Addendum 3

Webster High School – Band Room & Greenhouse Additions w/ Site Improvements

10/6/2022

TO: ALL OFFICIAL PLAN HOLDERS

C4.3

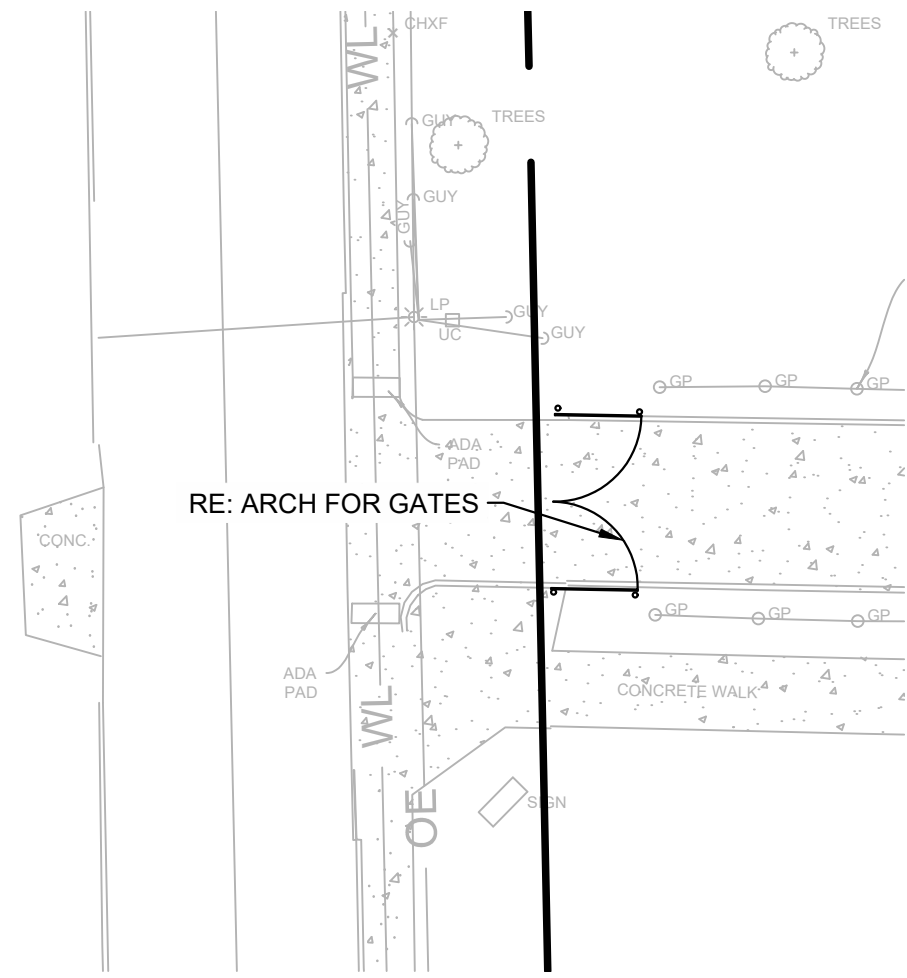
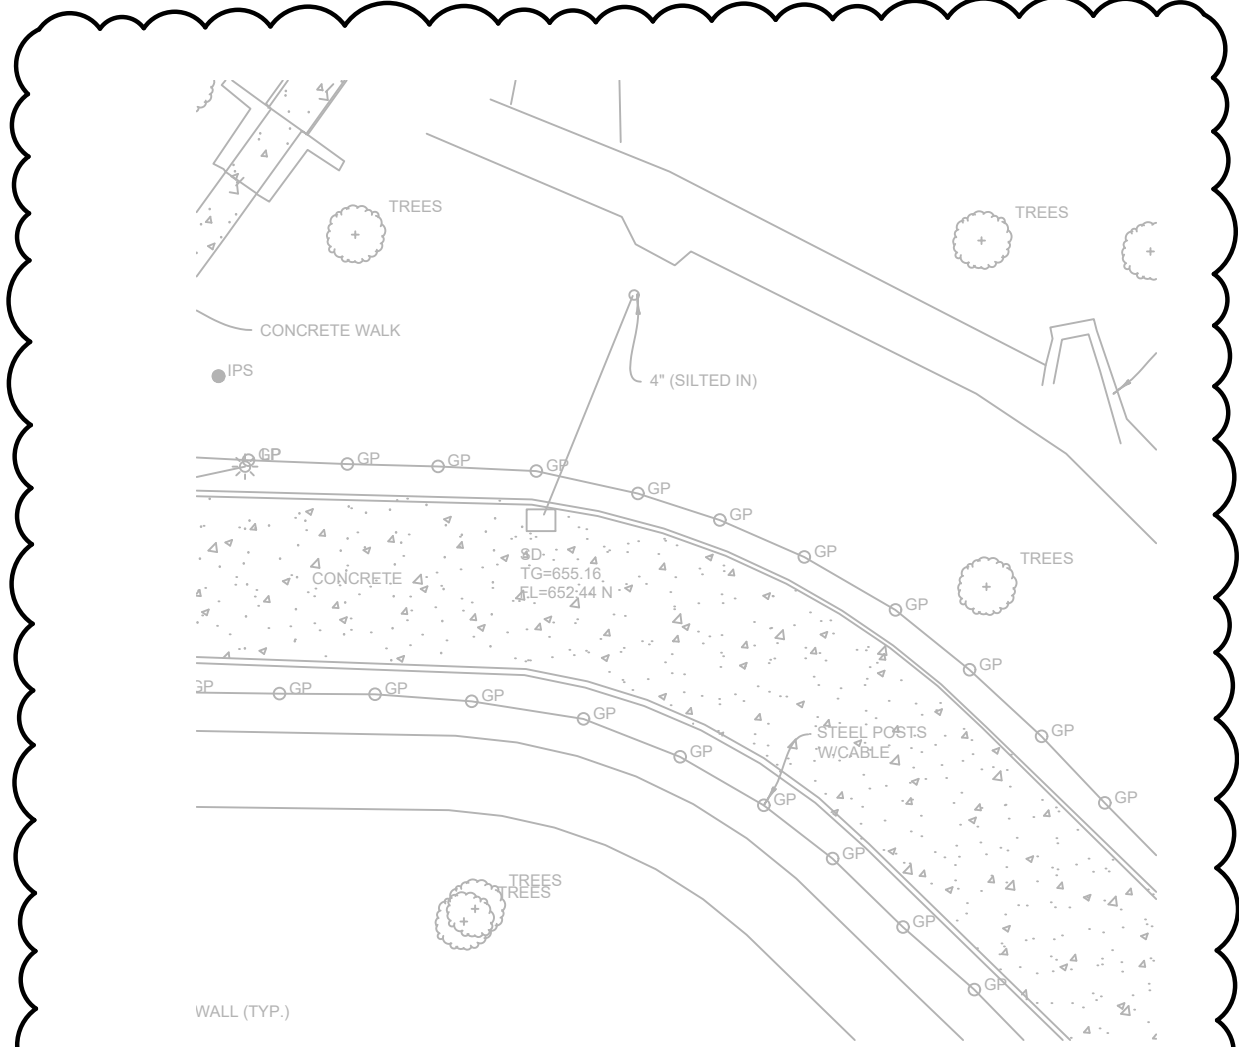
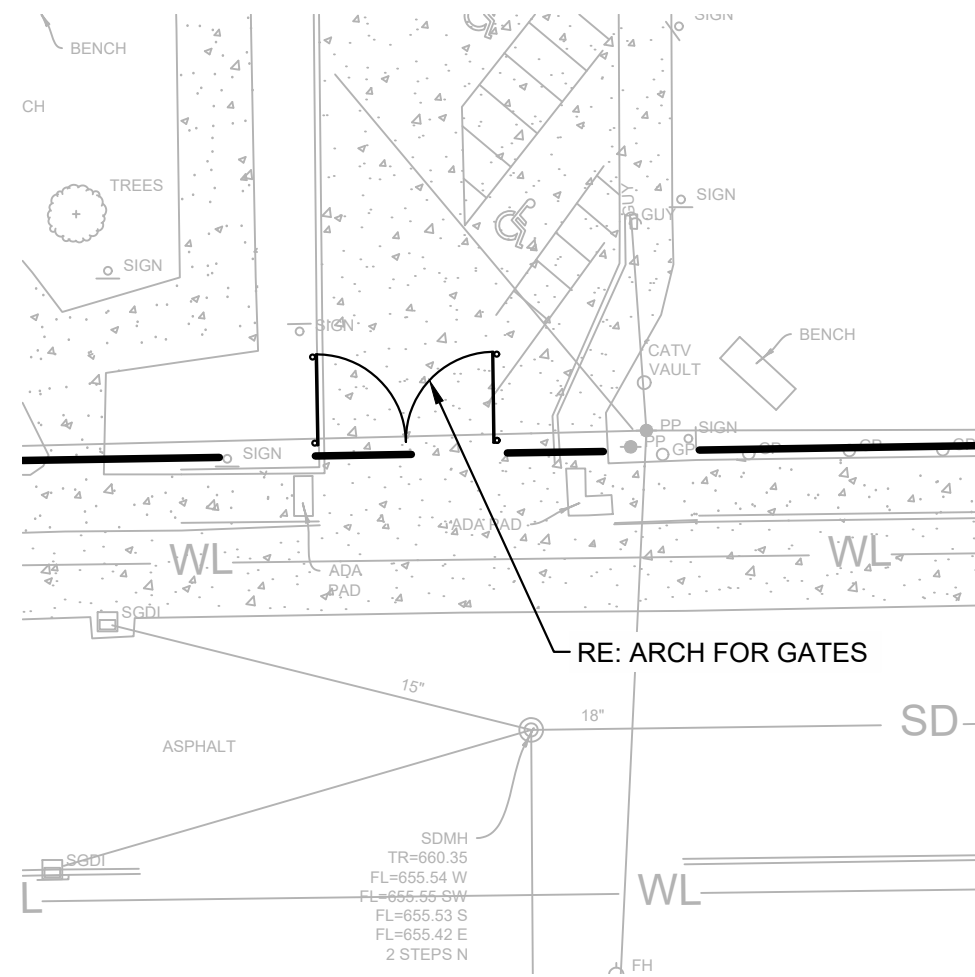
C4.3, SITE PLAN

SHEET TITLE: SITE PLAN

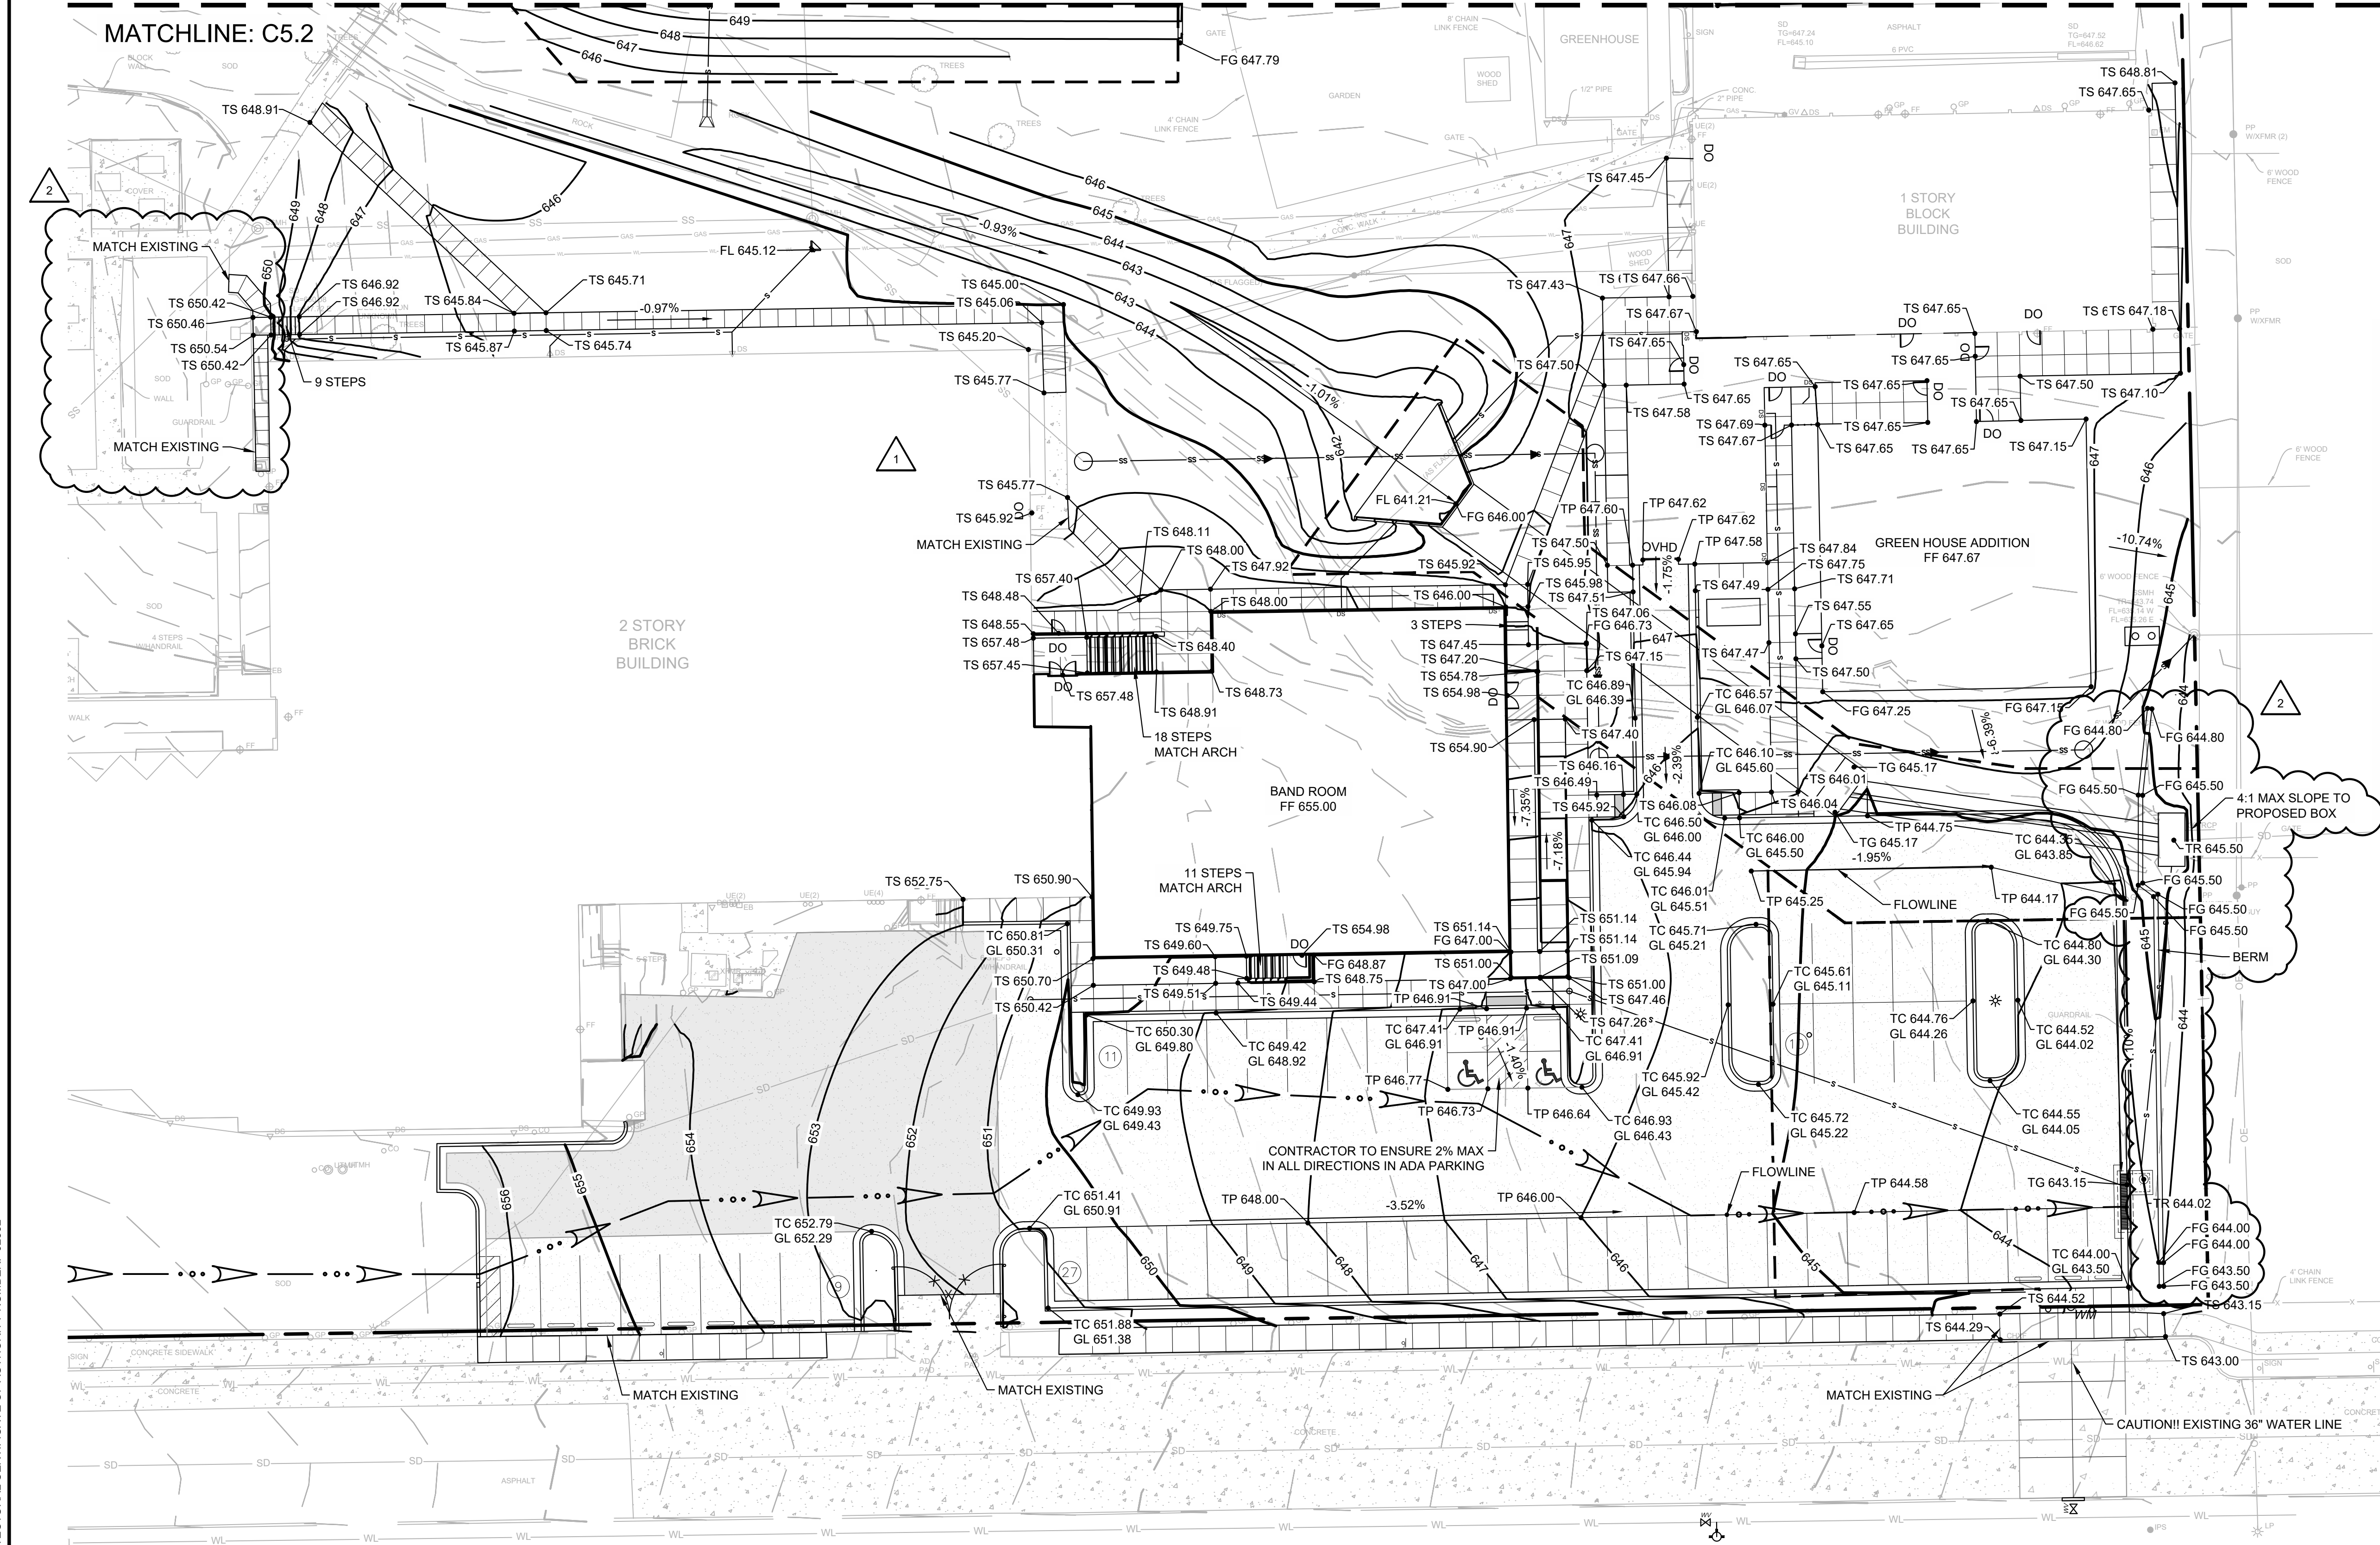
8. **Alternate #8 WEST PARKING LOT OVERLAY:** Provide ADDITIVE cost to provide all work required for the "Middle School" Parking Lot Mill Overlay & Restripe. Refer to Sheet 3/C.4.4 for additional information regarding this Alternate. The referenced "gate" is part of Alternate #9.

C4.4, SITE PLAN

C6.3

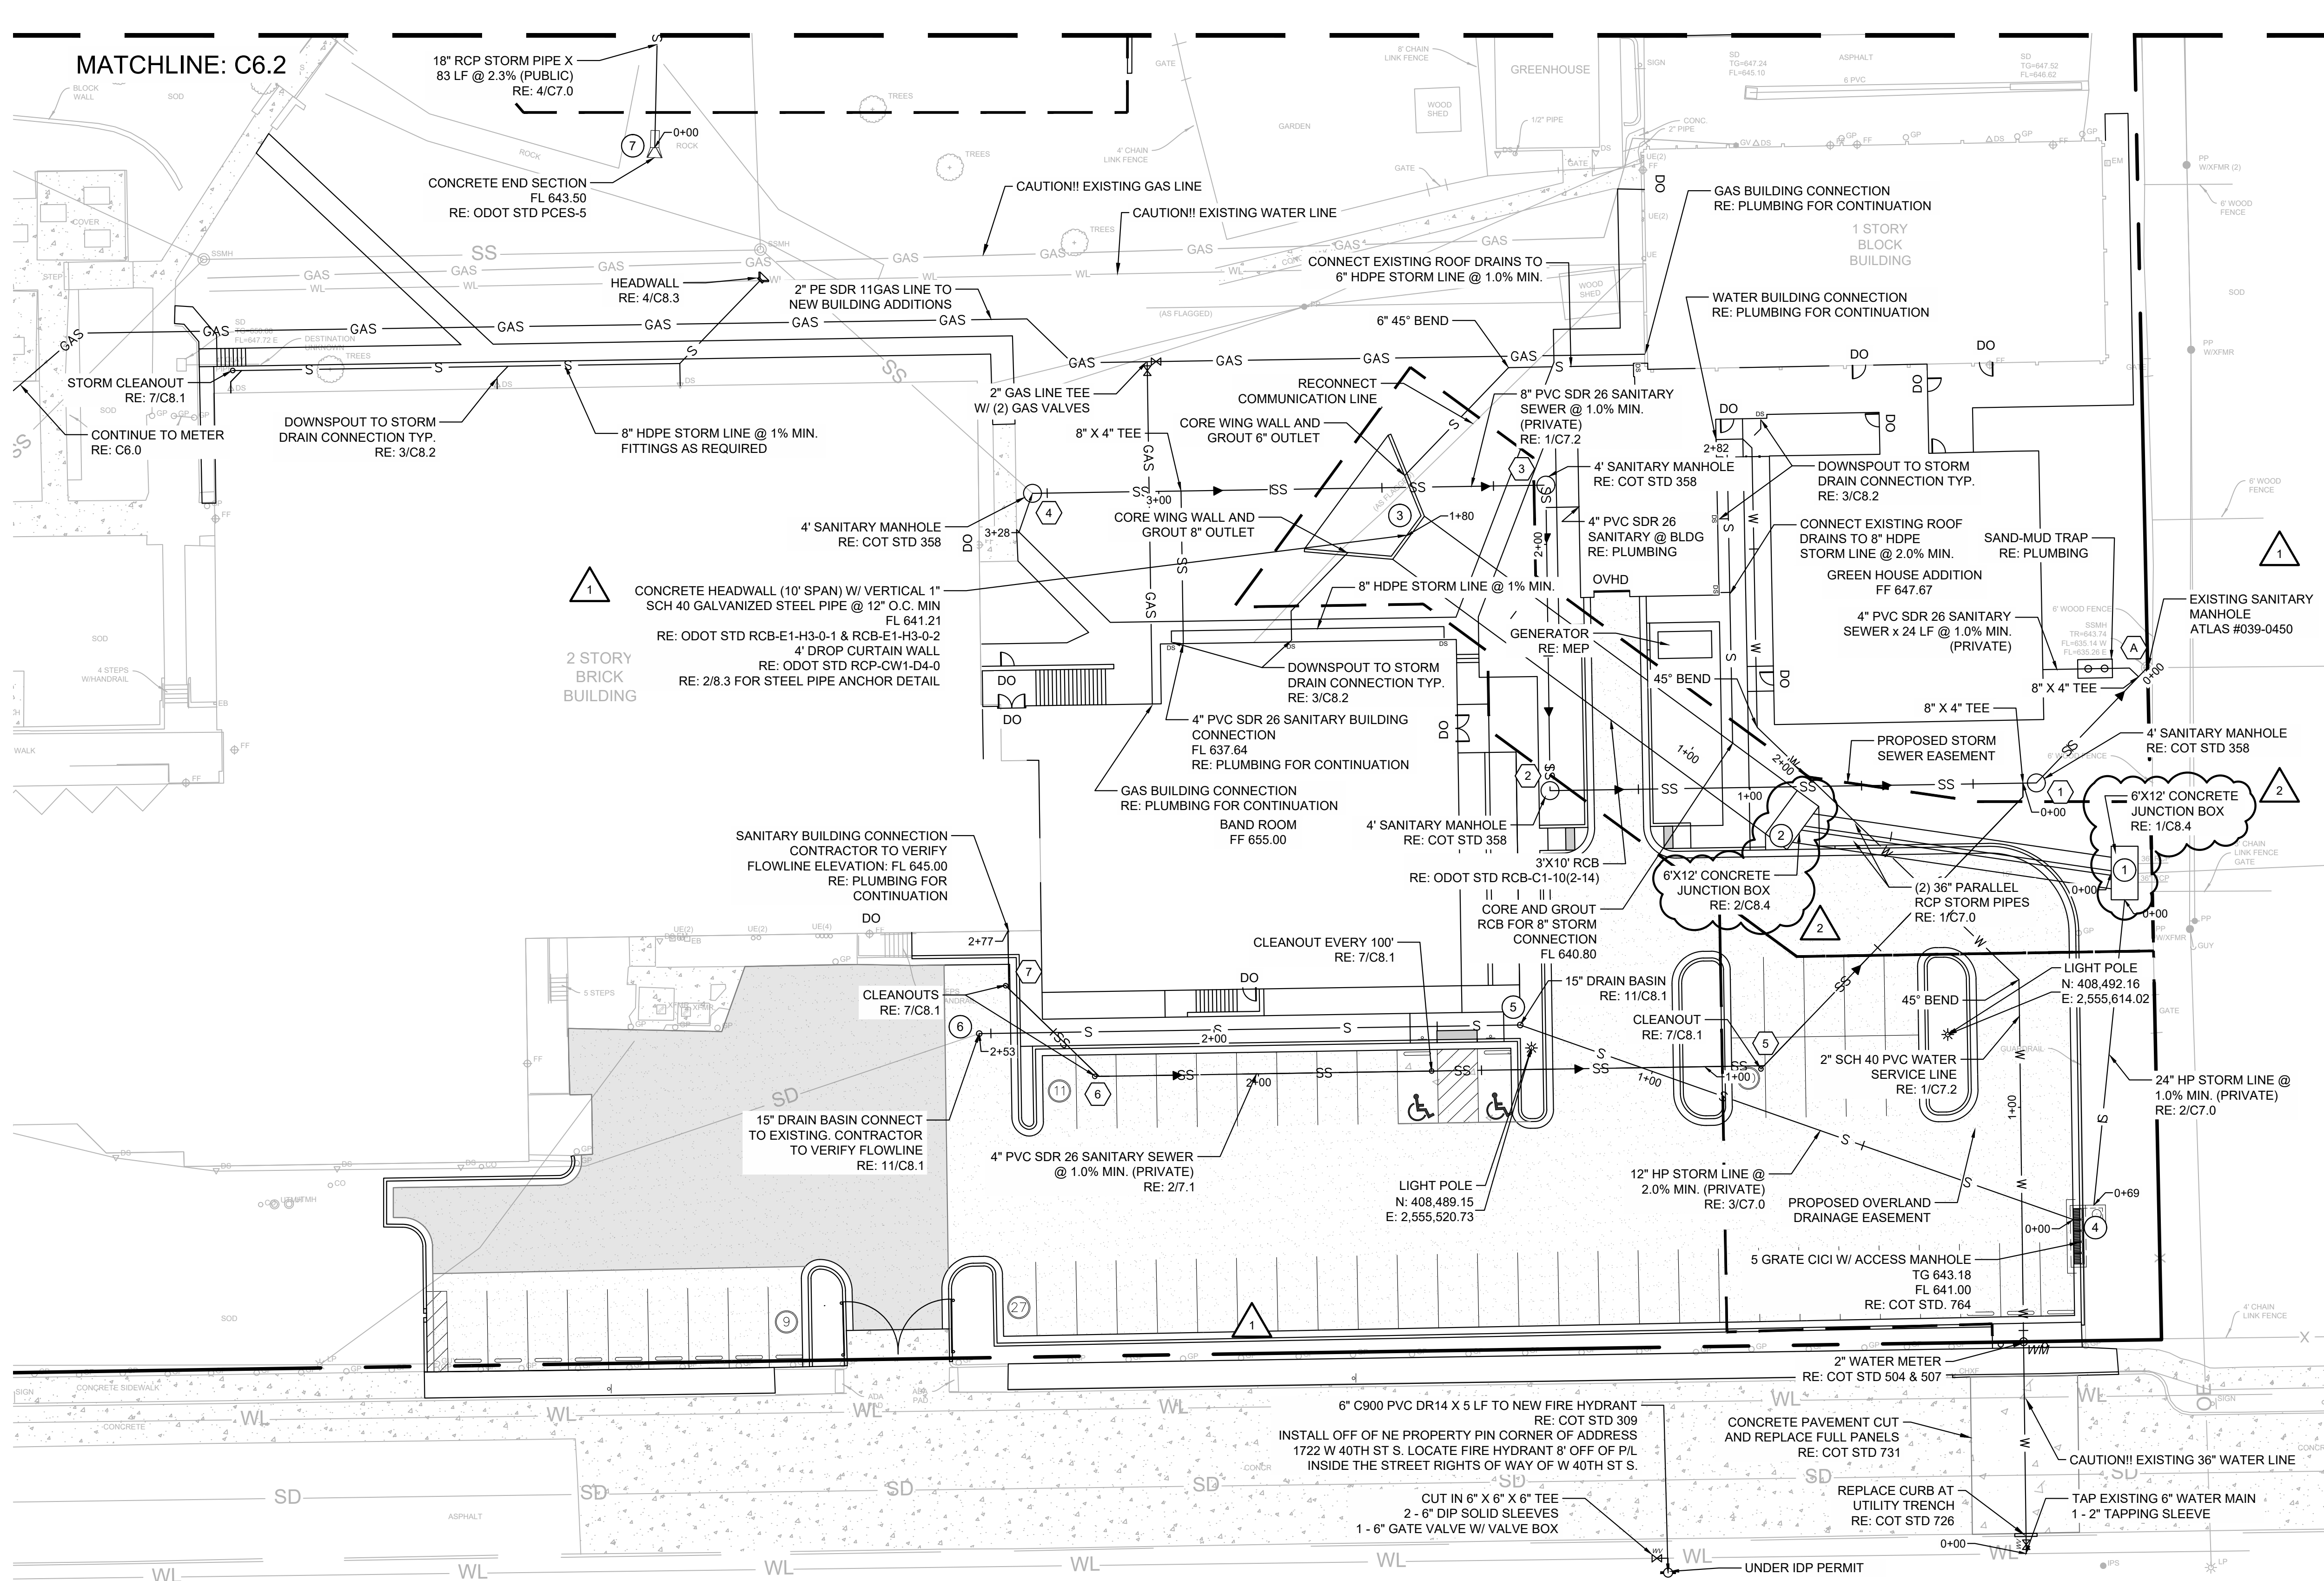
C6.3, UTILITY PLAN
